**Addendum No. 1**

Contract No.: DA00309

WBS Element: 44226

*Stone and Elevated Walkway Construction in Dare County*

# EROSION CONTROL PLAN

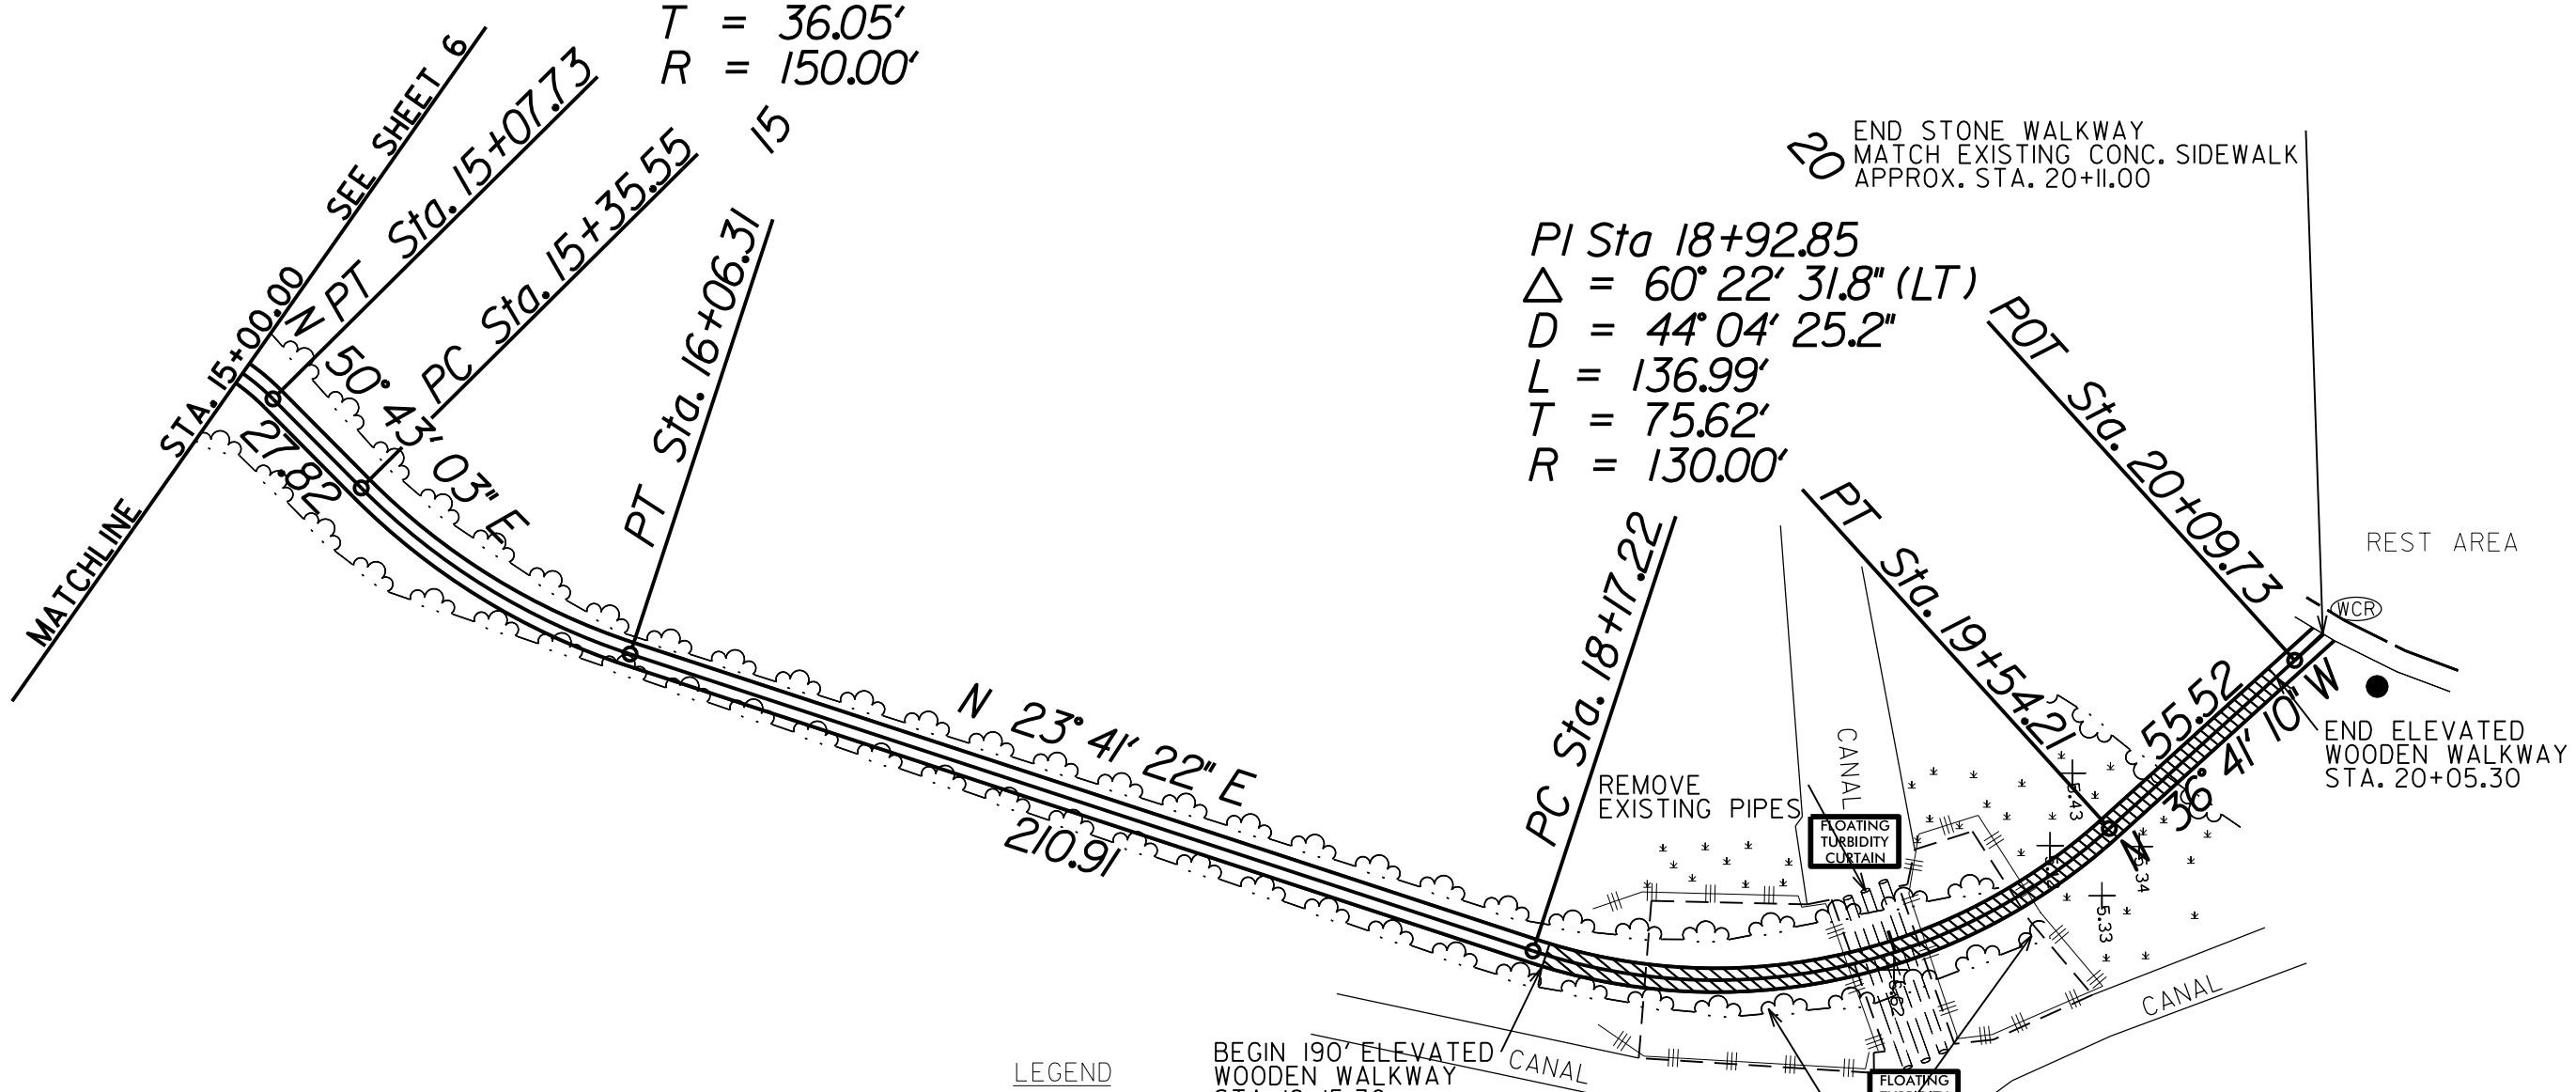
Plan Sheet No. 7 "Erosion Control Plan" has been revised to remove the note concerning the installation of the "Temporary Silt Fence" and to remove the note concerning "Floating Turbidity Curtain". Please void existing Plan Sheet No. 7 and replace with revised Plan Sheet No. 7.
